IMPORTANT RECALL INFORMATION #30815

**SUBJECT: RECALL CAMPAIGN # 30815
2002, 2003, and early 2004 Model Year Revolution Auxiliary Battery
Disconnect**

**SERVICE
BULLETIN:
#30815**

**SUBJECT:
Adding a 789
Conversion
Module to the
Battery Control
Center**

Figure 2

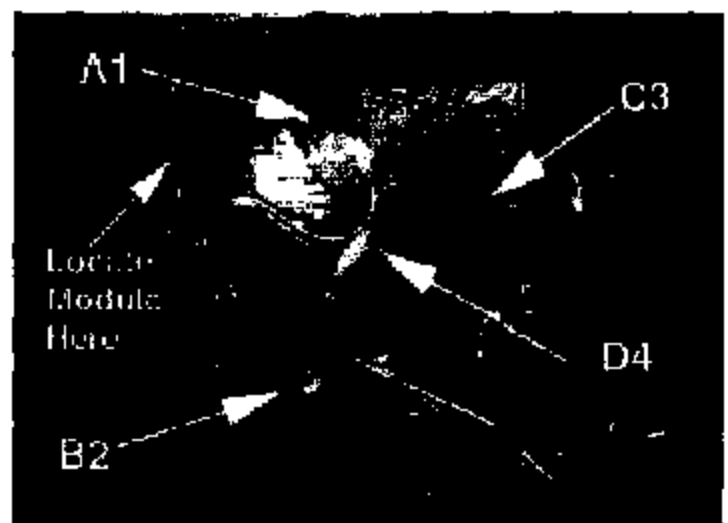
5. Connect the four-pin plug and socket (Figure 2, items "A" and "B" wired directly to the new Module) to the respective plugs "#1" and "#2" in the Battery Control Center. Module plug "A" will connect to harness plug "#1" making the connection "A1" and Module plug "B" will connect to harness plug "#2" making the connection "B2". See Figure 3.

6. Locate and pull the four-pin plug "#4" from the printed circuit board "#3". See Figure 1.
7. Plug the short jumper harness plug "C" (Figure 2) into the PC board connector "#3" making connection "C3". See Figures 2 and 3.

8. Plug the remaining Battery Control Center harness plug "#4" into the other end of the short jumper harness plug "D" making connection "D4". See Figures 2 and 3.

9. The new Module will be attached to the inside of the Battery Control Center Box along side the isolator relay and secured with the double back tape strips already fastened to the new Module. Clean the area of dirt and oil before attaching. See Figure 3.
